TECHNICAL BULLETIN 2013-09

Resolute Acclaim 2490 Arch Brick Redesign

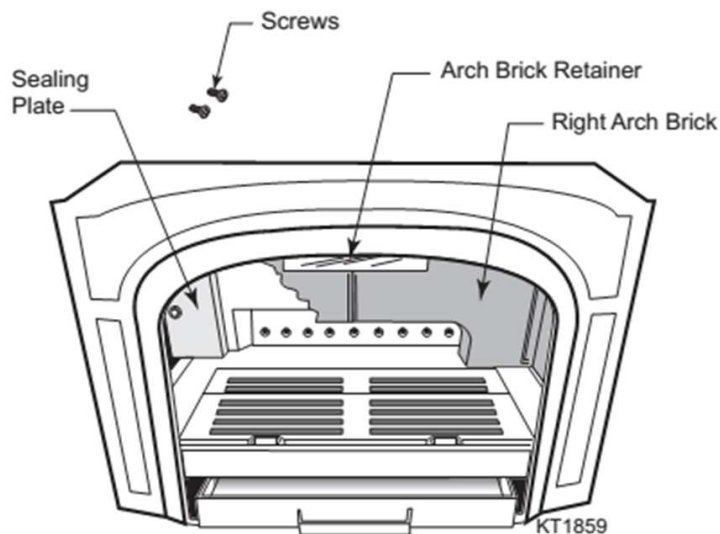
The Vermont Casting Group has redesigned the inner brick system on the Resolute Acclaim Model 2490. The left and right arch bricks have been redesigned to be flat on the back and more robust. The arch brick retainer used to hold both arch bricks has been redesigned. Side brackets have been added to the inner sides to hold the left and right side bricks more securely. Also left and right cast sealing plates (behind the arch bricks) have been redesigned with a tapered hole so flat head bolts may be used to secure them to the back. This will allow the new arch bricks to better sit flat against the sealing plates reducing breakage and simplifying the arch brick design.

The new arch bricks are not backwards compatible with the old arch bricks. Vermont will no longer make the old arch bricks so when stock of the old left and right arch bricks is used up, the sub for replacing the old arch bricks will be **Arch Brick Kit #30006595**. The kit includes:

If only one pre May 2013 arch brick needs replacing, both arch bricks will need to be replaced at the same time using the kit as the new bricks do not mate with the old.

- 1) redesigned left and right arch bricks
- 2) new arch brick retainer
- 3) two new sealing plates
- 4) new flat head bolts for the sealing plates
- 5) instructions
